NMGH Modular Offices
Crumpsall, Manchester

RIBA Stage 4 Acoustic Design Review

P1919-REP01-REV C-BDH

16 February 2021

Figure 3: Deflection Head Detail 1 (recommended trim angles indicated)

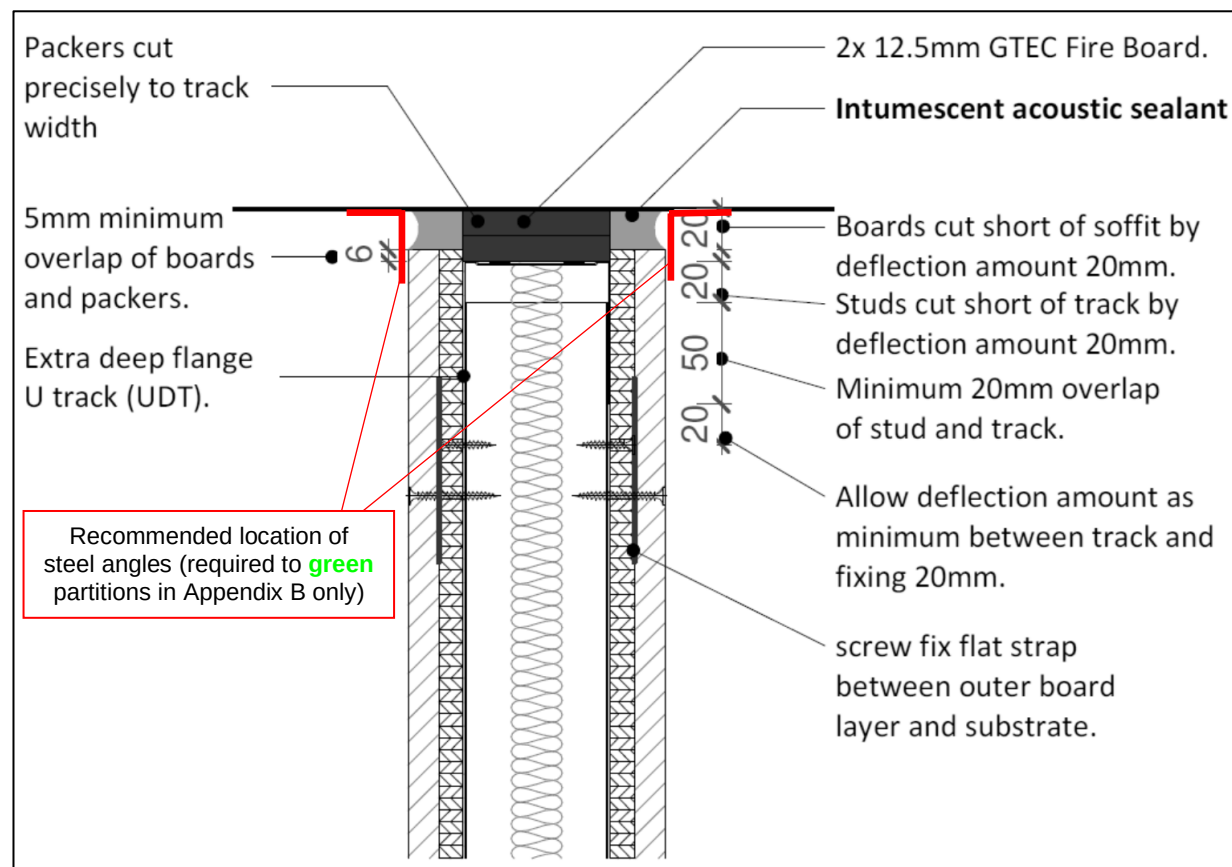
With regards to Deflection Head Detail 1 and for partitions highlighted in **green** in Appendix B, it is recommended that steel angles be fitted to the underside of the soffit either side of the partition to ensure that any gaps, as a result of onsite workmanship etc. are suitably closed. A sketch of this is shown in Figure 3:

Figure 4: Recommended noise mitigation measures to reduce noise impact from externally sited plant area

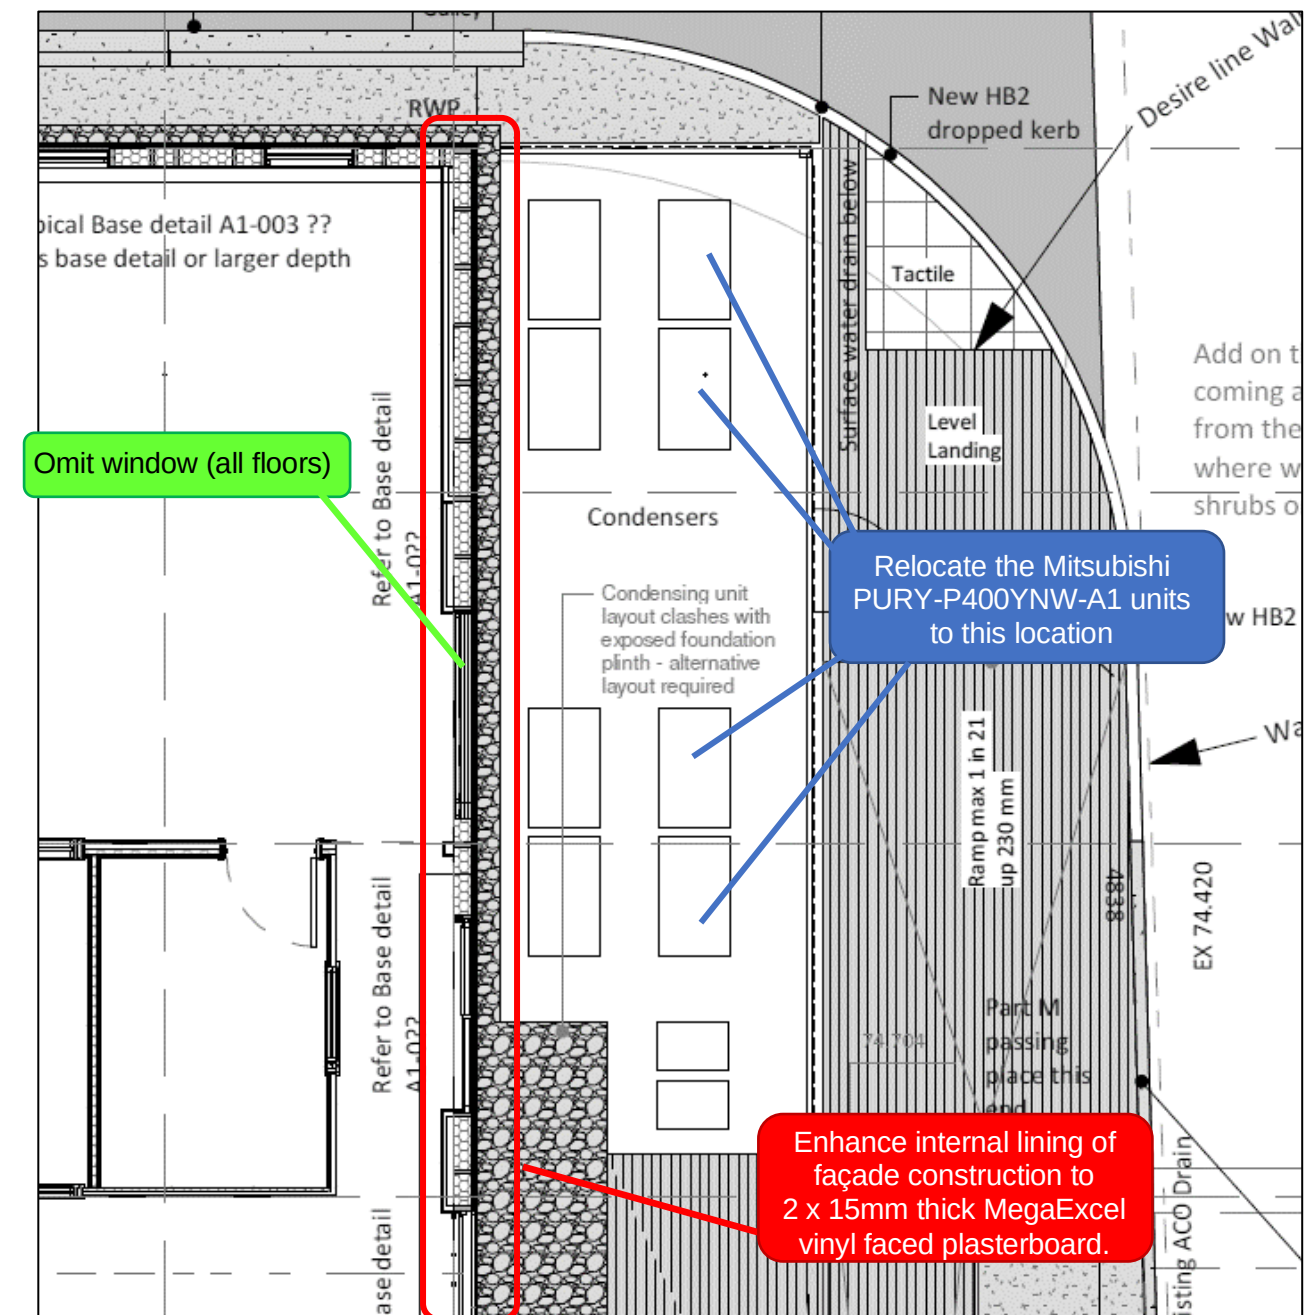
The proposed external condenser units are to be sited within an external plant area located directly to the north of the proposed development. Based upon the details provided, noise from the proposed condenser units is expected to exceed the maximum permissible internal Noise Rating limit of NR35 within the adjacent open plan office spaces. In order to reduce the noise impact generated, it is recommended that the following noise mitigation measures be implemented on site:

- Omit (or infill via double skin black out panelling) the currently proposed external glazing on the north façade (all floors) to all open plan office spaces adjacent to the external plant area.
- Increase the internal lining of the external façade construction to 2 x 15mm thick MegaExcel vinyl faced plasterboard.
- Locate the 4 off Mitsubishi PURY-P400YNW-A1 units (plant ref: C02, C05, C08, C11) to be furthest away from the building façade.

The recommended noise mitigation measures are shown in Figure 4:

Figure 5: Typical crosstalk attenuator arrangement

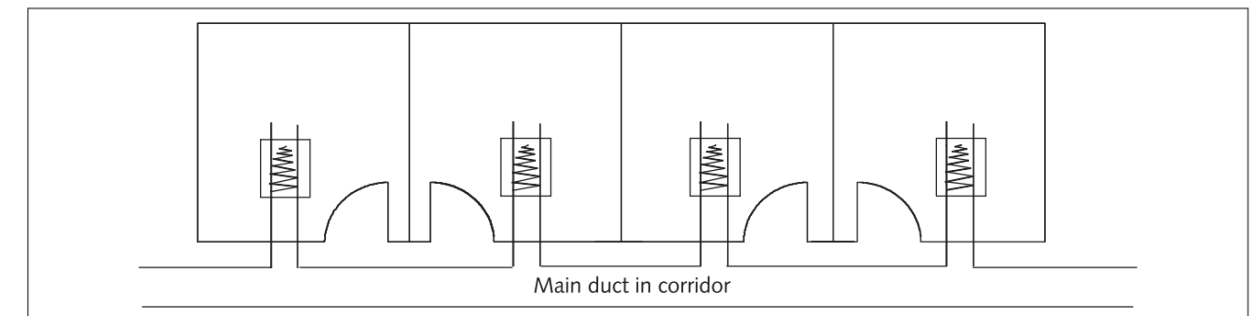
“Crosstalk” describes the level of sound transmission between separate rooms via common ductwork connections. The use of crosstalk attenuators are required in order to control sound transmission between spaces in order to maintain the sound insulation performance. **NB: crosstalk attenuators are not currently shown in the ventilation drawings and will need to be added.**

The crosstalk attenuator shall be installed as close as practicable to the duct penetration through the separating wall. Any ductwork serving cellular spaces, such as Meeting Rooms and Quiet Rooms, shall enter the spaces via the corridor wall (ideally above the room doorset) only. Ductwork penetrations through walls separating Quiet Rooms and/or Meeting Rooms are not permitted.

Figure 5 shows the required arrangement. This principle applies to both the supply and extract ductwork systems:

NB: the current ventilation drawings indicate a number of locations where the ductwork is expected to penetrate the separating walls in these locations and must therefore be revised.

In this arrangement there will be at least two crosstalk attenuators in series between any two adjacent spaces. On this basis, Table 16 provides the minimum required insertion loss performance to be achieved by all crosstalk attenuators. **NB: again, crosstalk attenuators are not currently shown in the ventilation drawings and these will need to be added in all instances:**

Figure B1: Ground Floor Sound Insulation mark-up

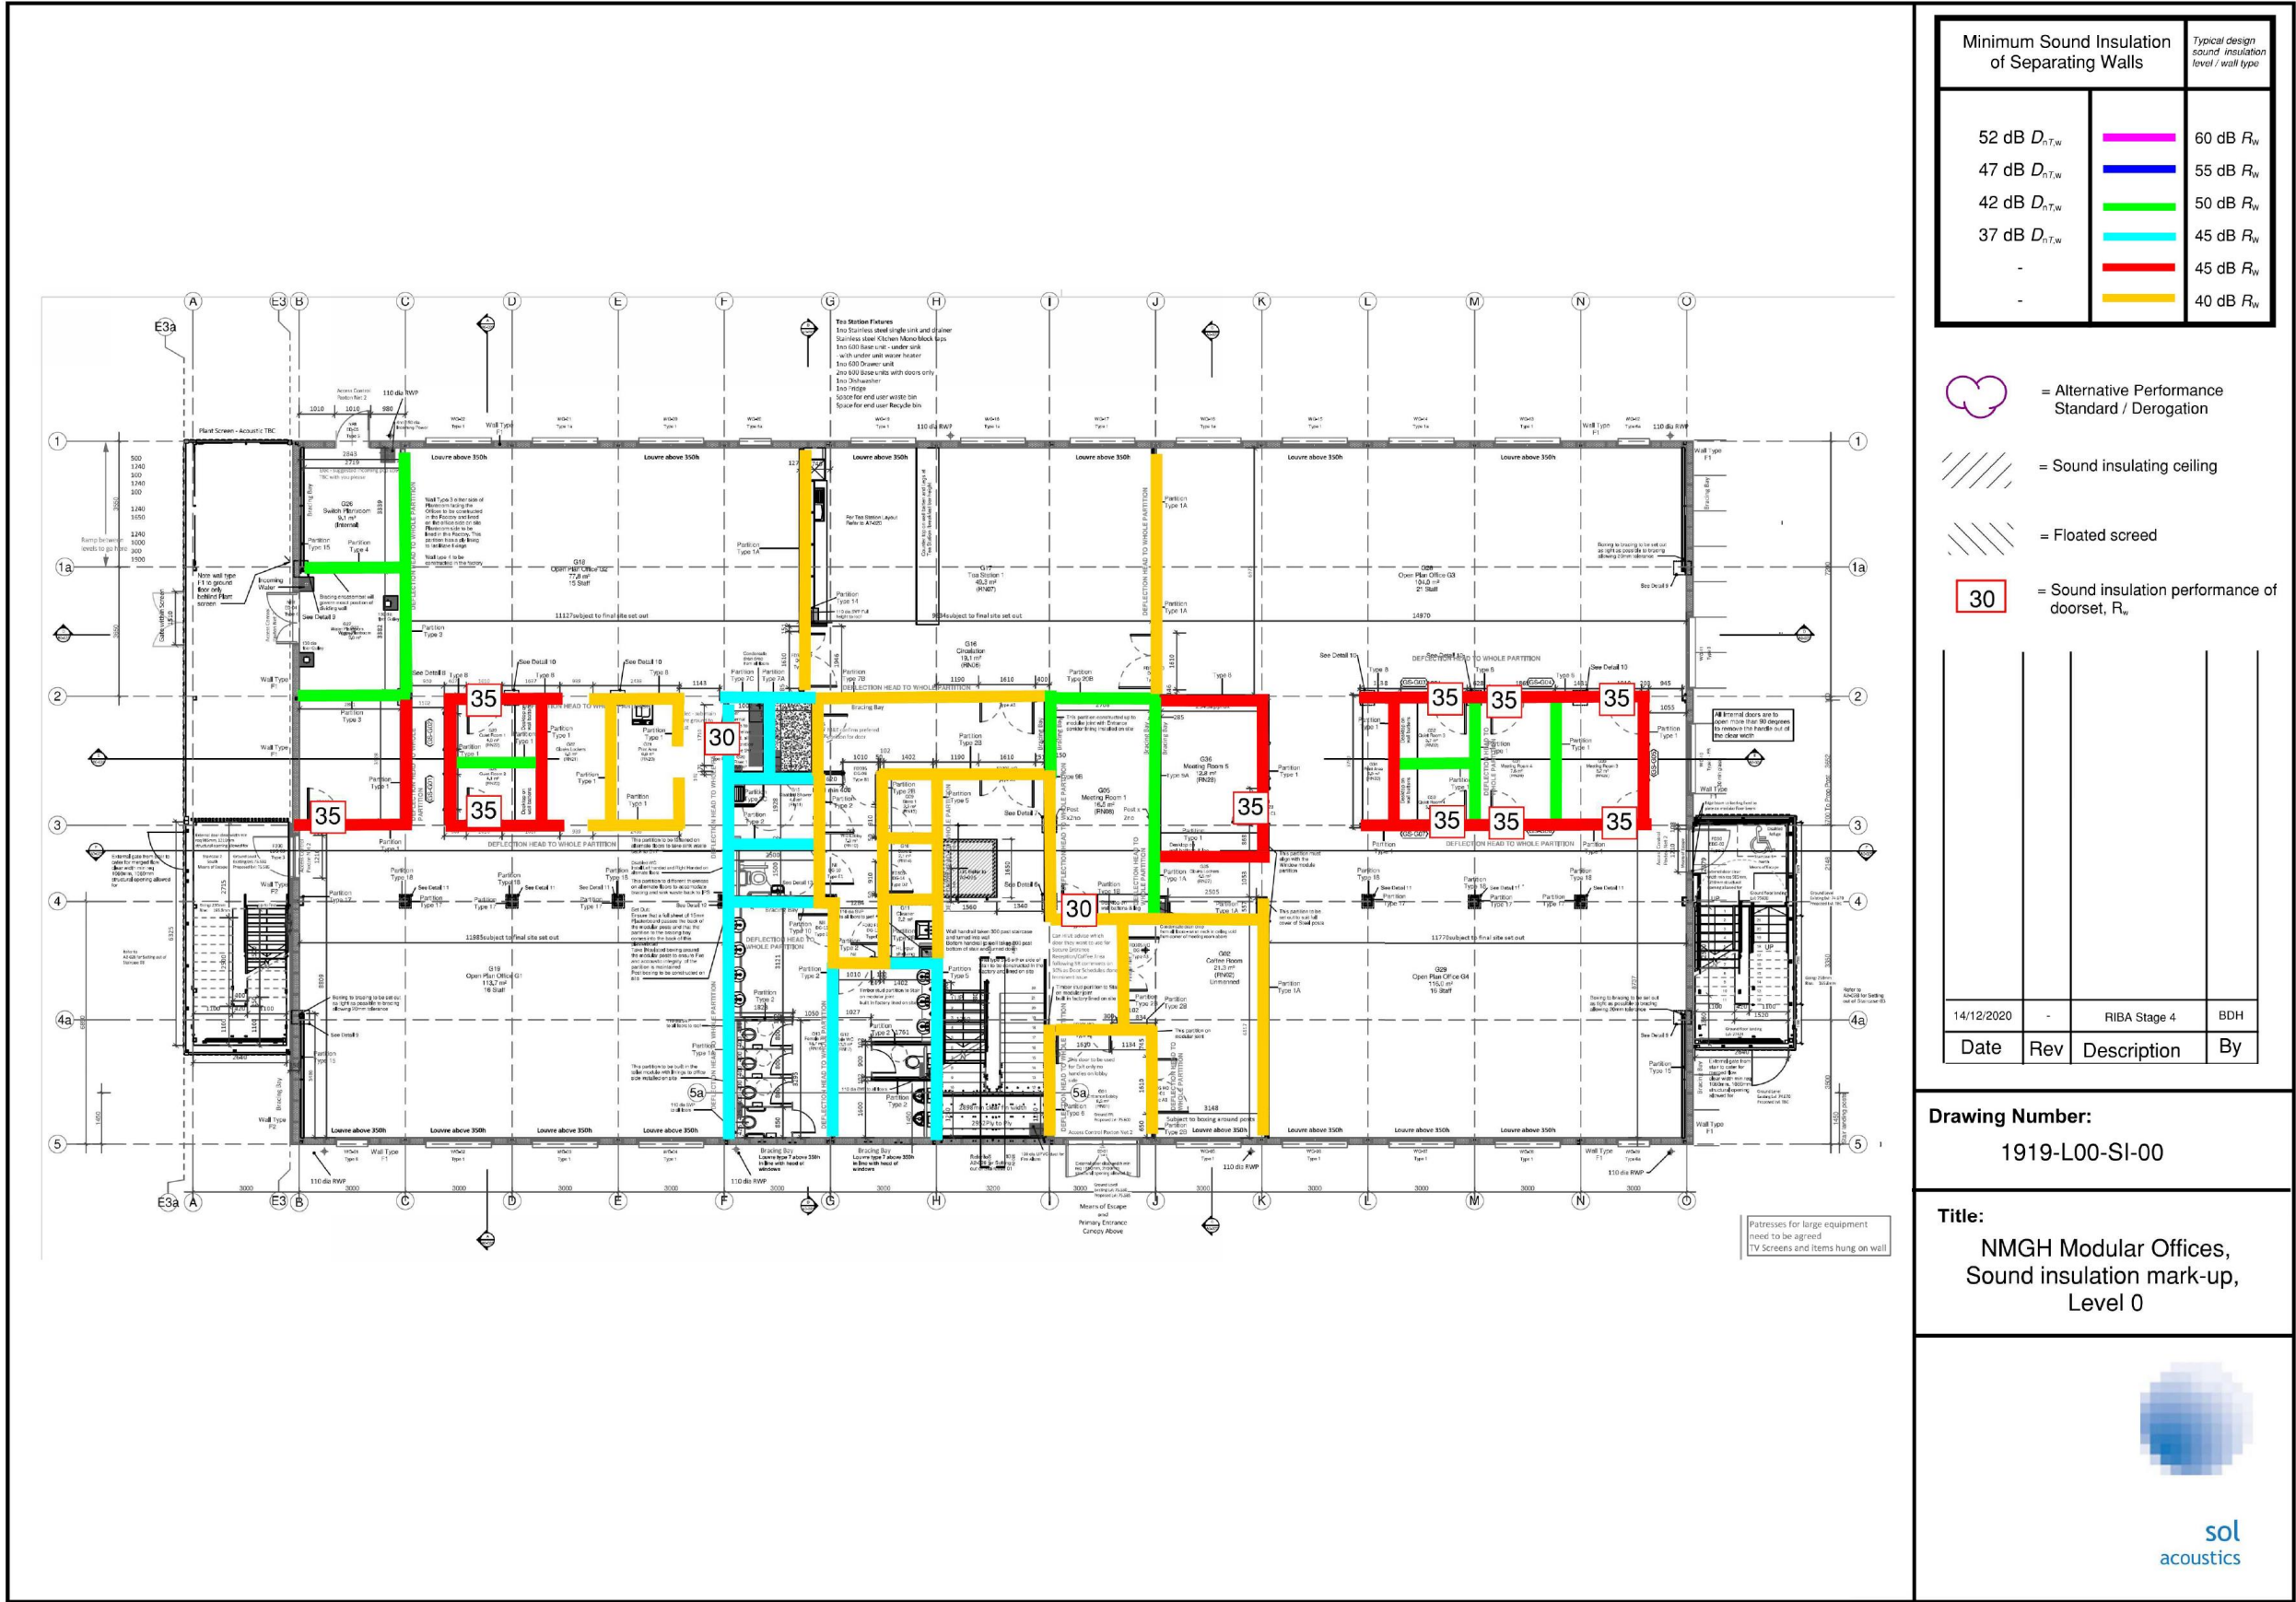
- For partitions highlighted in **light blue** or **red** in Appendix B, it would be possible (in acoustic terms only) to omit the 1 x 12.5mm thick GTEC standard plasterboard on both sides of the stud and to reduce the thickness of the glass mineral wool insulation from 50mm to 25mm.
- For partitions highlighted in **orange** in Appendix B, it would be possible (in acoustic terms only) to omit the 1 x 12.5mm thick GTEC Standard plasterboard on both sides of the stud and also the 50mm thick glass mineral wool insulation.

- For partitions highlighted in **orange** in Appendix B, it would be possible (in acoustic terms only) to omit 25mm thick glass mineral wool insulation.

This partition type is proposed to be located between the ground floor electrical plantroom, and open plan office and meeting room spaces. It is recommended that this partition be rated to provide a laboratory sound insulation performance of 50dB R_w . **Further enhancement of the current proposed partition construction is therefore required.**

- For partitions highlighted in **orange** in Appendix B, it would be possible (in acoustic terms only) to omit the 50mm thick glass mineral wool insulation.

- For partitions highlighted in **orange** in Appendix B, it would be possible (in acoustic terms only) to omit the 50mm thick glass mineral wool insulation.

- For partitions highlighted in **green**, **light blue** or **red** in Appendix B, it would be possible (in acoustic terms only) to omit one layer of plasterboard each side of the stud.
- For partitions highlighted in **orange** in Appendix B, it would be possible (in acoustic terms only) to omit one layer of plasterboard each side of the stud and the 50mm thick acoustic insulation.
